Esperanza Hills Project

2018 Additional Environmental Analysis

Project No. PA120037
August 2018

Attachment B
Revised Maps Depicting Location of Chino Hills State Park

Exhibit 5-100

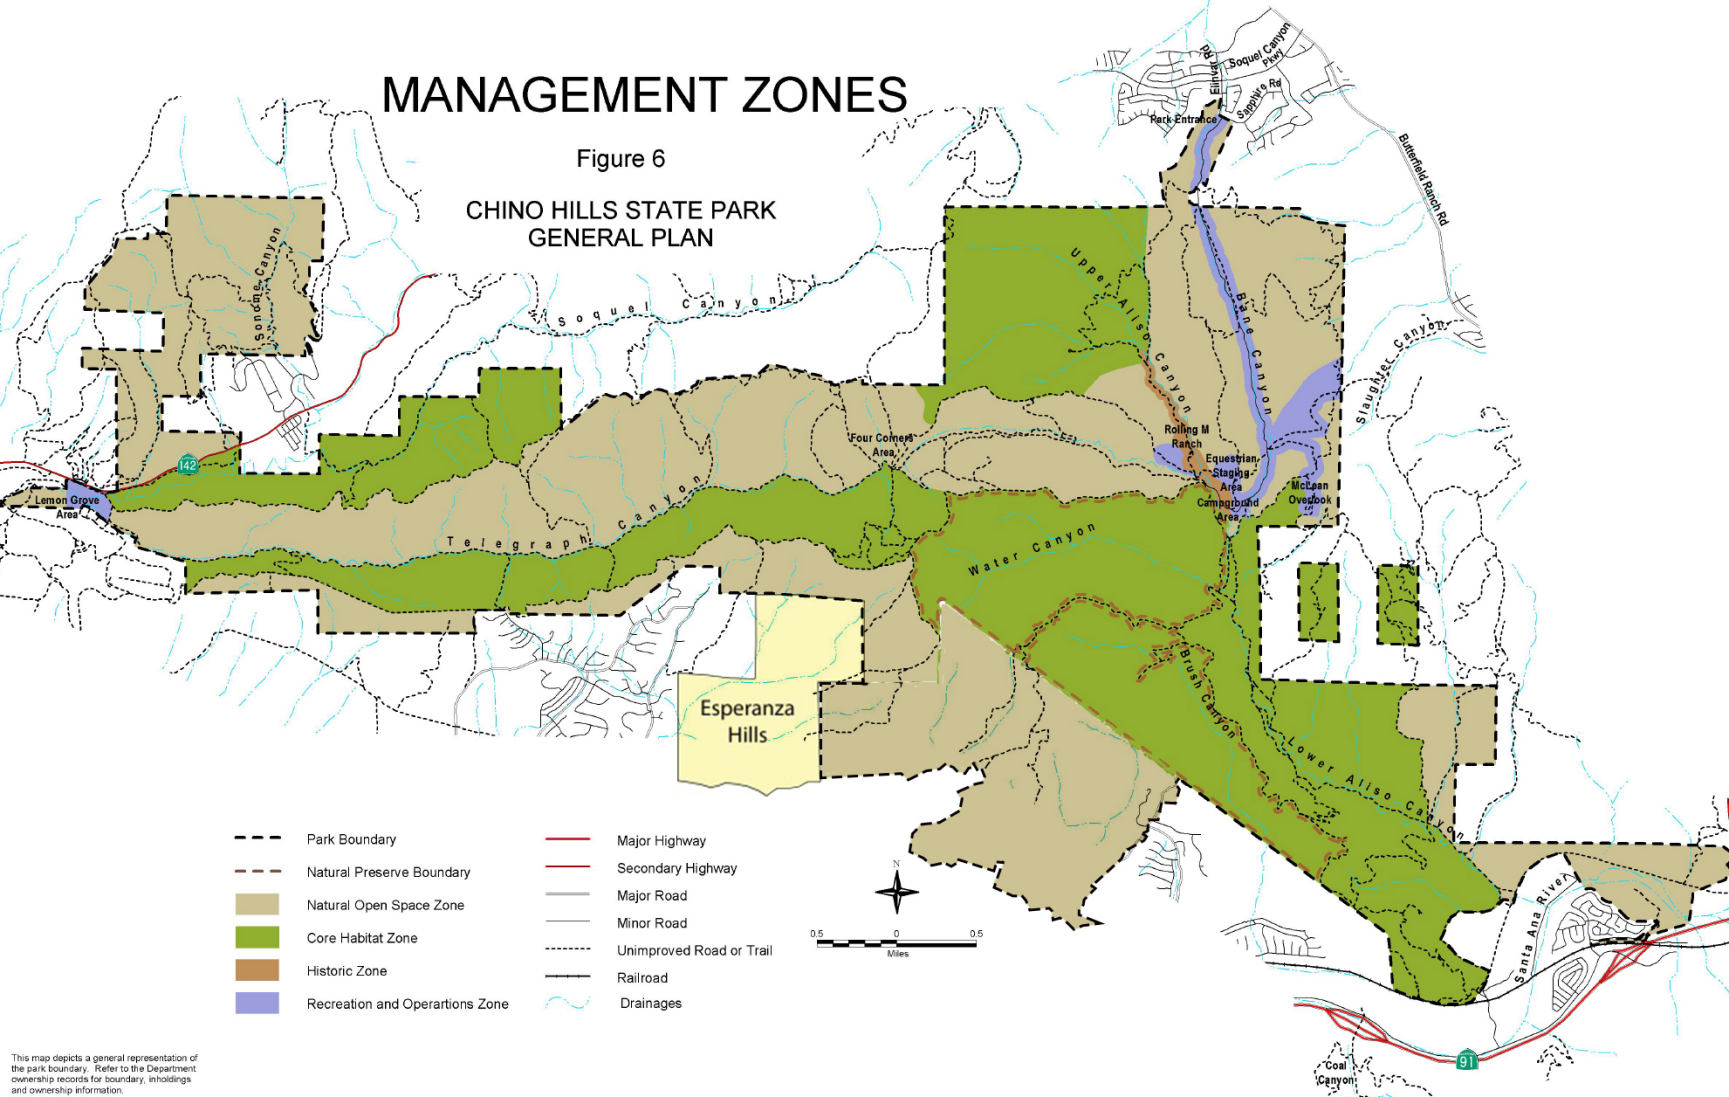
Exhibit 5-100 – Chino Hills State Park General Plan in Chapter 5, Section 5.9.2, was updated to reflect the current property boundaries of CHSP. The management zone to the east of the Project Site was shown as Natural Open Space Zone as State Park personnel confirmed that the management zones had not changed.

Exhibit 5-100 showed the management zones for CHSP and was derived from the CHSP General Plan, the map from which has never been changed to reflect additions to the CHSP acreage made subsequently. In connection with this Second RFEIR, however, Exhibit 5-100 was updated to show the correct boundaries of CHSP to the east of the Project site.

Exhibit 5-108

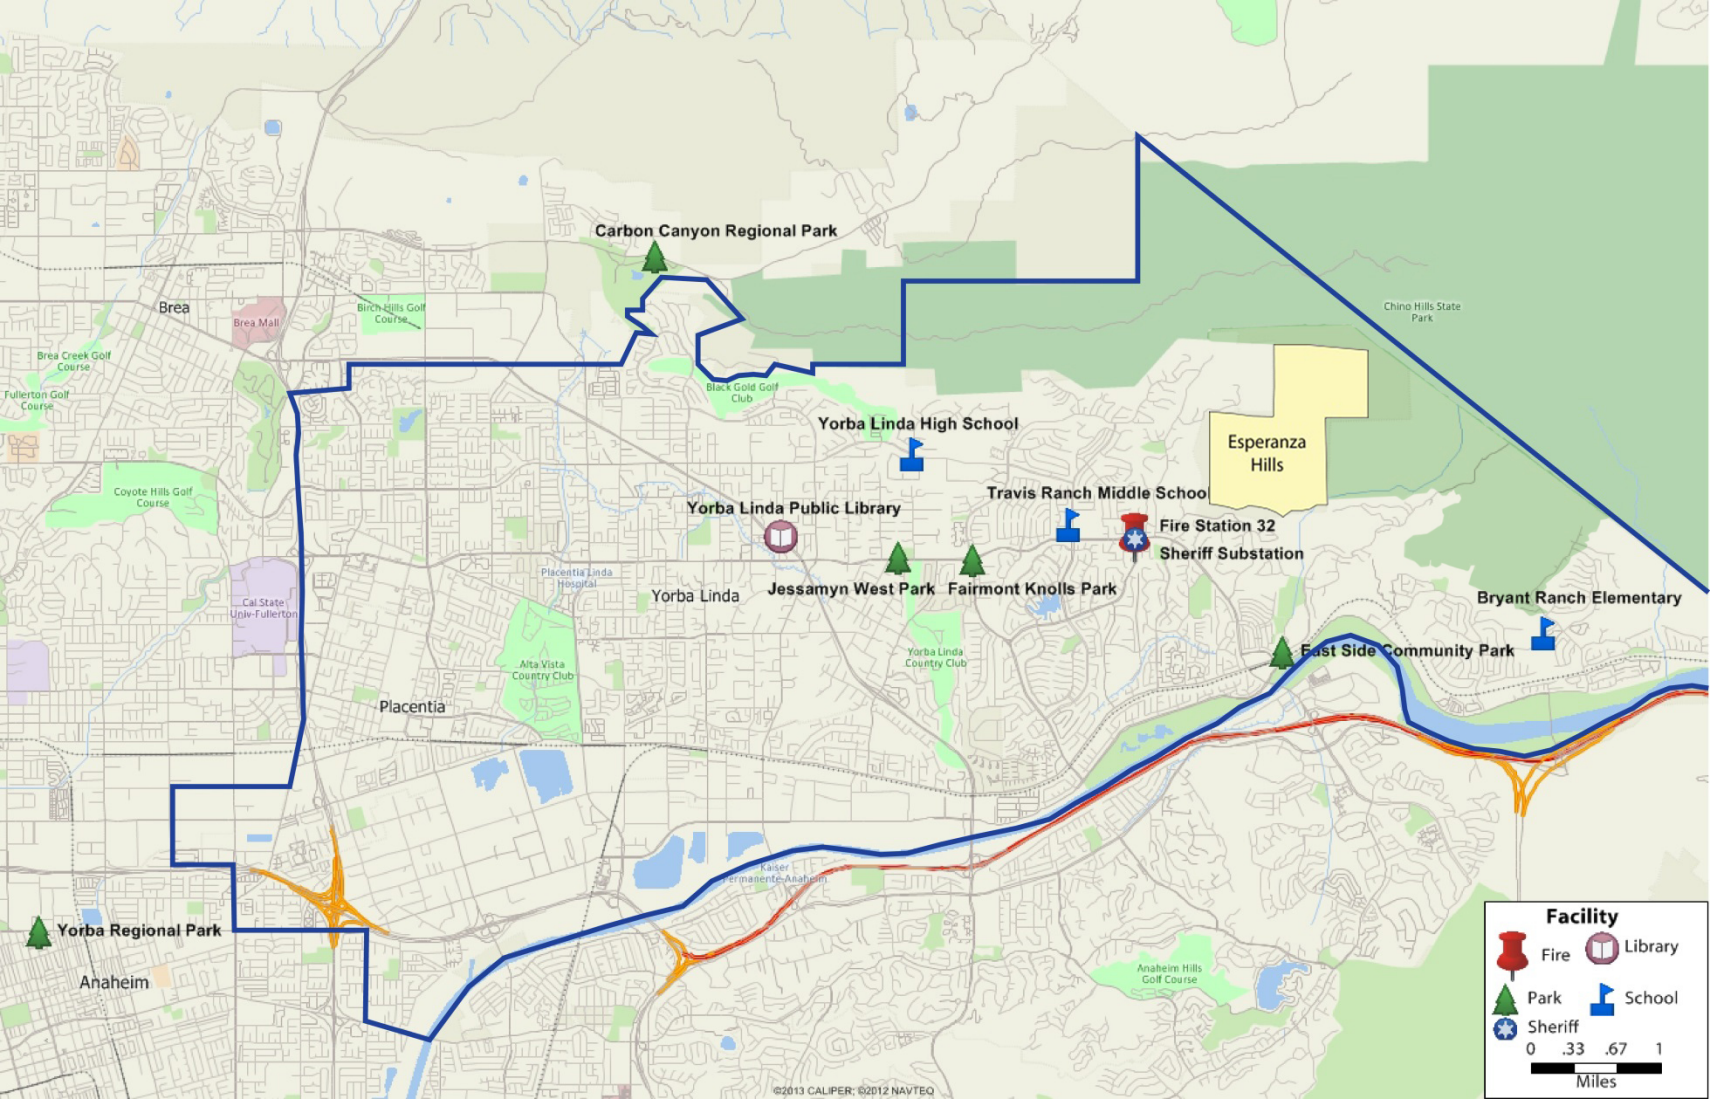
Exhibit 5-108 – Public Facilities Recreation Locations, in Chapter 5, Section 5.12.1, was updated to show the proper boundaries of CHSP to the north and east of the Project Site.

**CONCEPTUAL TRAILS PLAN
STONEHAVEN DRIVE OPTION 1
ESPERANZA HILLS
YORBA LINDA, CALIFORNIA**

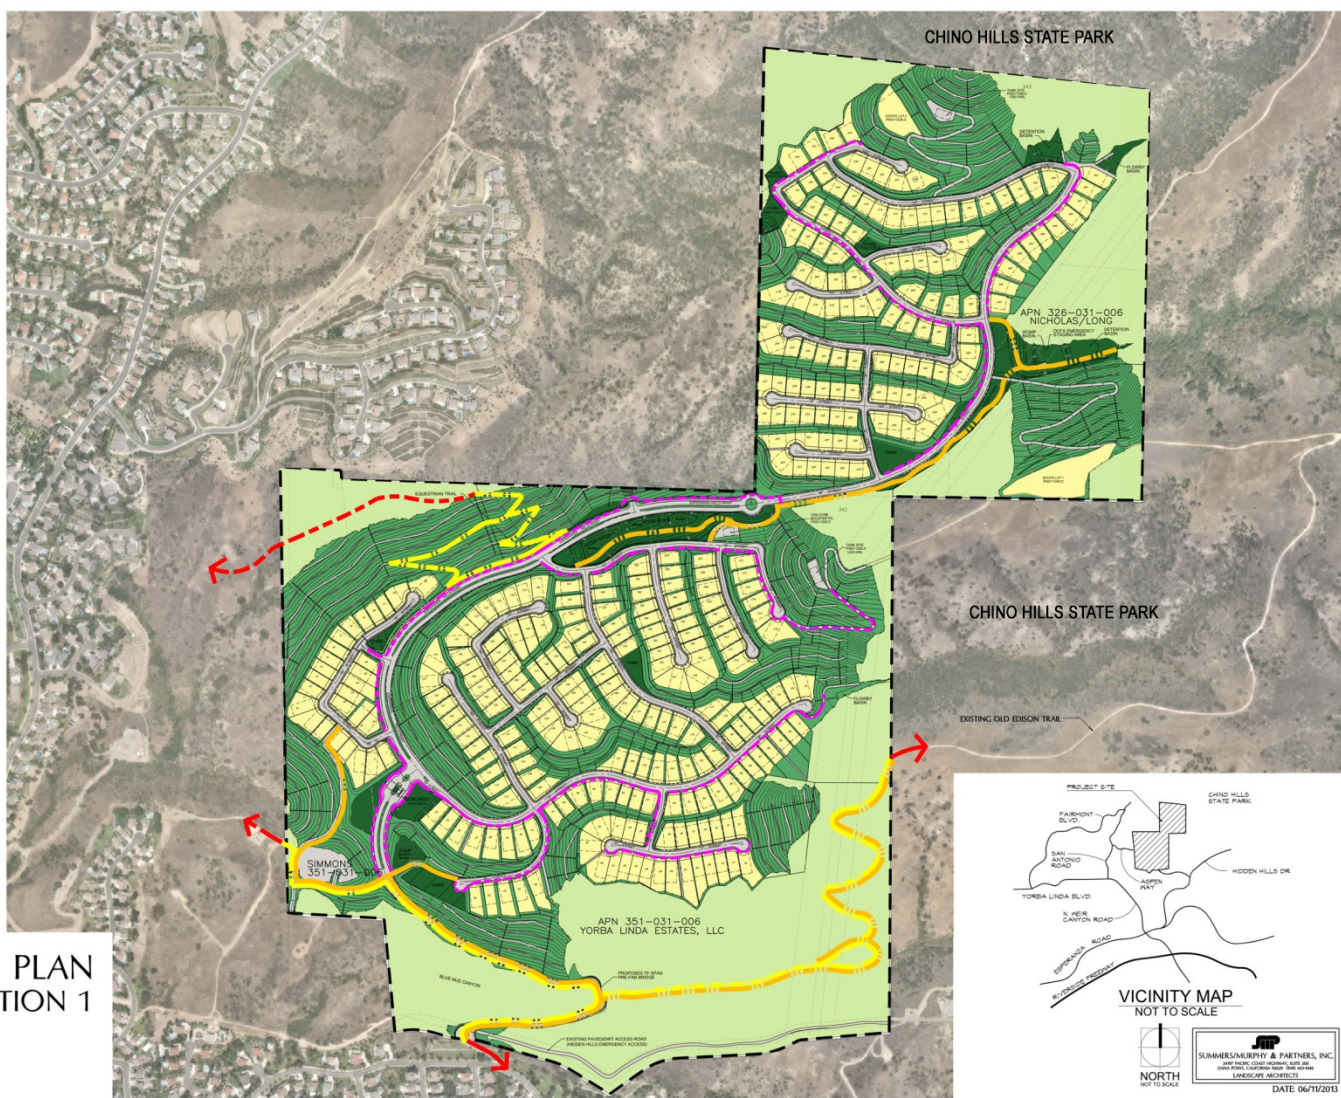
Exhibit 5-125 – Conceptual Trails Plan, Option 1 – Stonehaven Drive in Chapter 5, Section 5.13, was updated by adding the text “Chino Hills State Park” above the connection for a trail to the Existing Old Edison Trail just to make it clearer as to the location of CHSP.

**CONCEPTUAL TRAILS PLAN
ASPEN WAY OPTION 2
ESPERANZA HILLS
YORBA LINDA, CALIFORNIA**

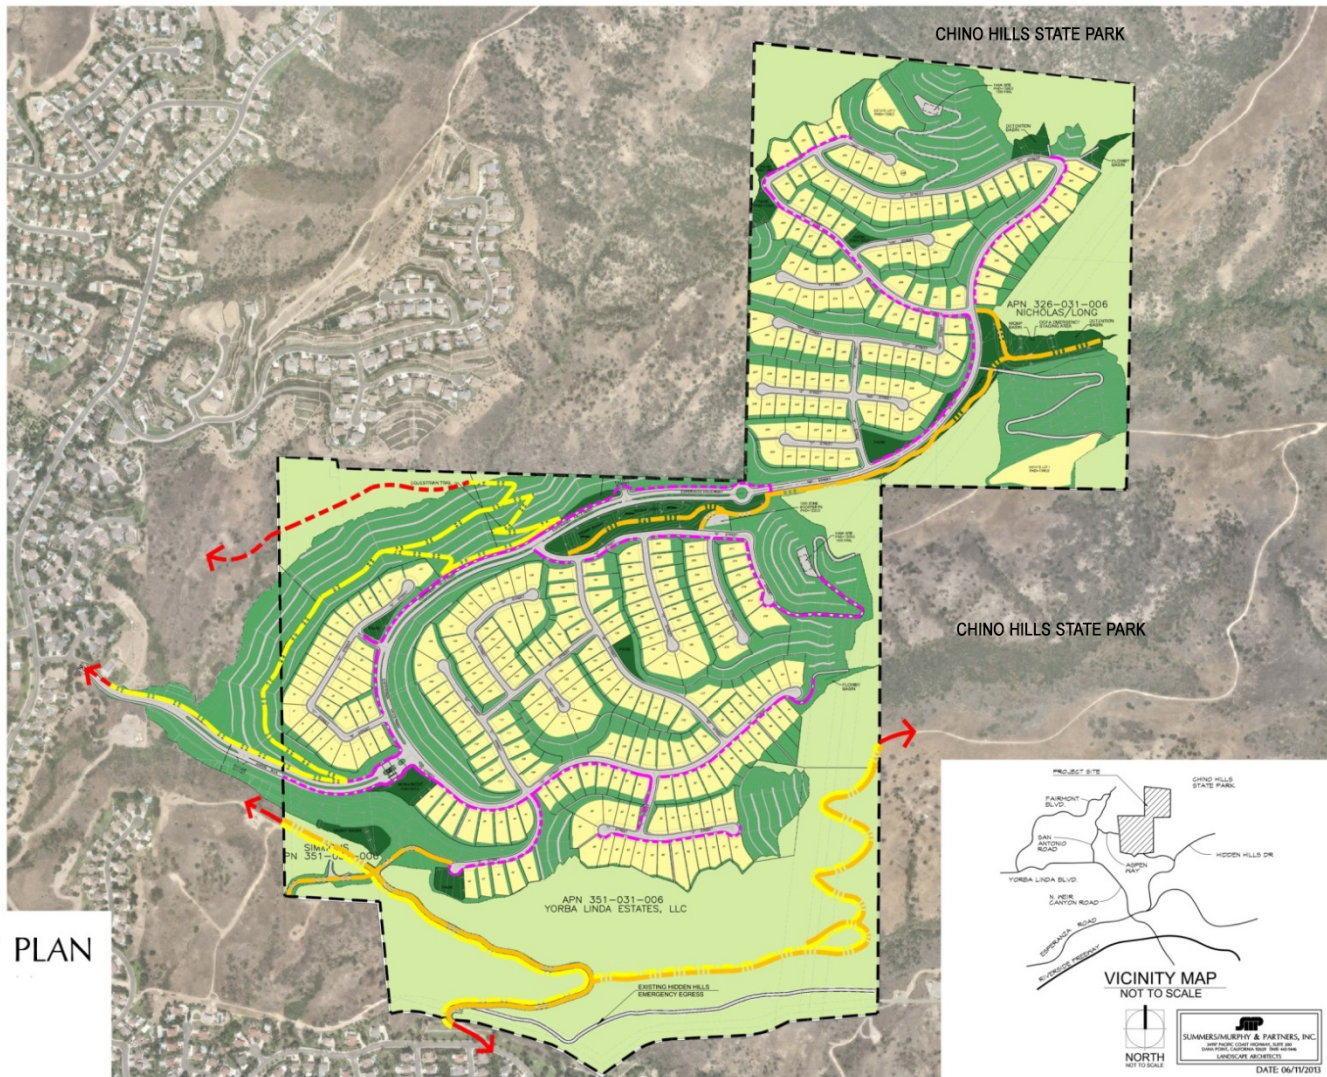
Exhibit 5-126 – Conceptual Trails Plan, Option 2 – Aspen Way, in Chapter 5, Section 5.13, was updated by adding the text “Chino Hills State Park” above the connection for a trail to the Existing Old Edison Trail just to make it clearer as to the location of CHSP.

Exhibit 5-127

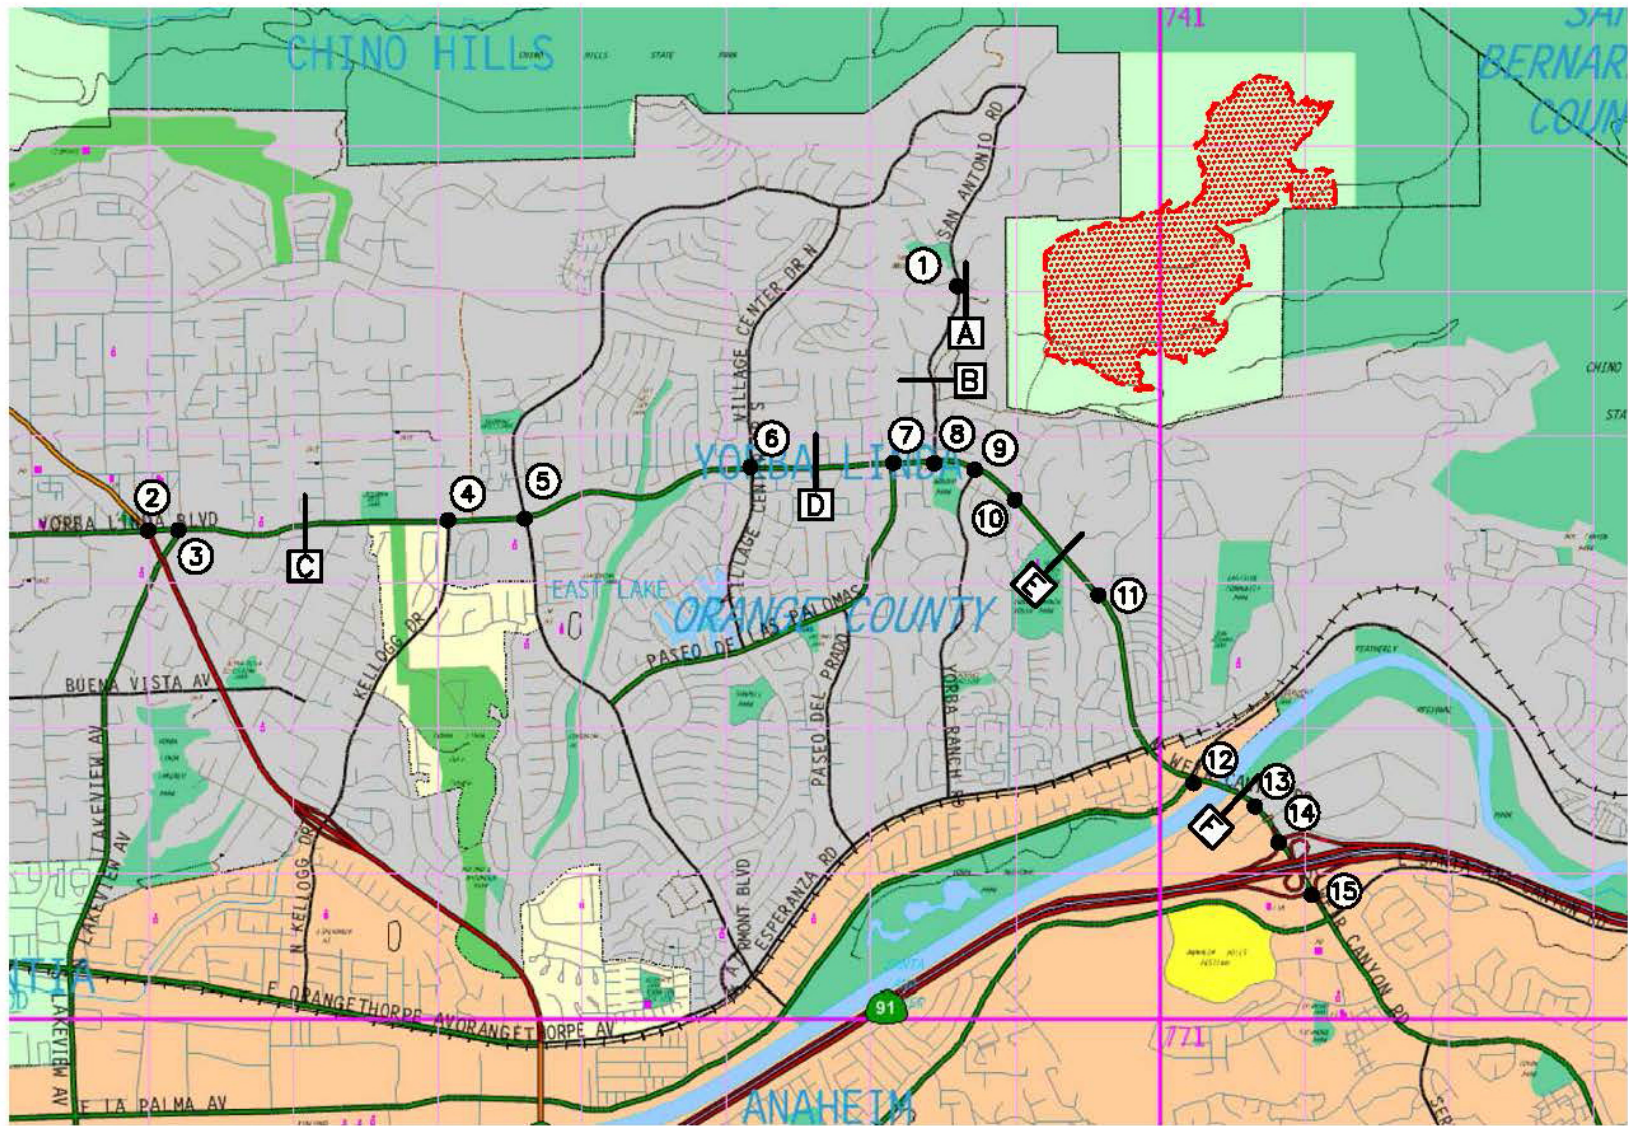
Exhibit 5-127 – Key Intersection Map, from Thomas Brothers, in Chapter 5, Section 5.14, was updated to show that the grading for Esperanza Hills did not intrude into CHSP.
